Access Compliance Report

Public Rights-of-Way

(Curb Ramps)

Intersection ID: 15175	Main Street: SOUTH_BV	Cross Street: POINDEXTER_DR	Location: NE
ADA ID: 6DF5A39CC3D5	Ramp Type: Para	Initial Pass/Fail: Fail	Overall Compliance: No
		Severity Score: 12.5

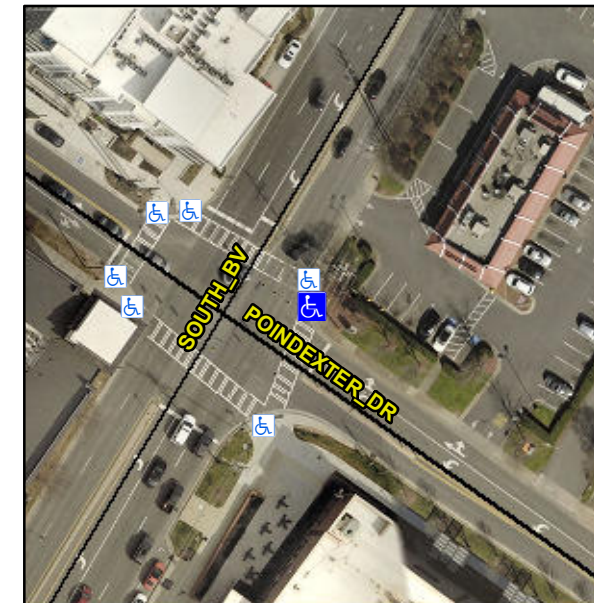
LT RP < 5%

R304.3.2

Remove & Replace Entire Ramp.
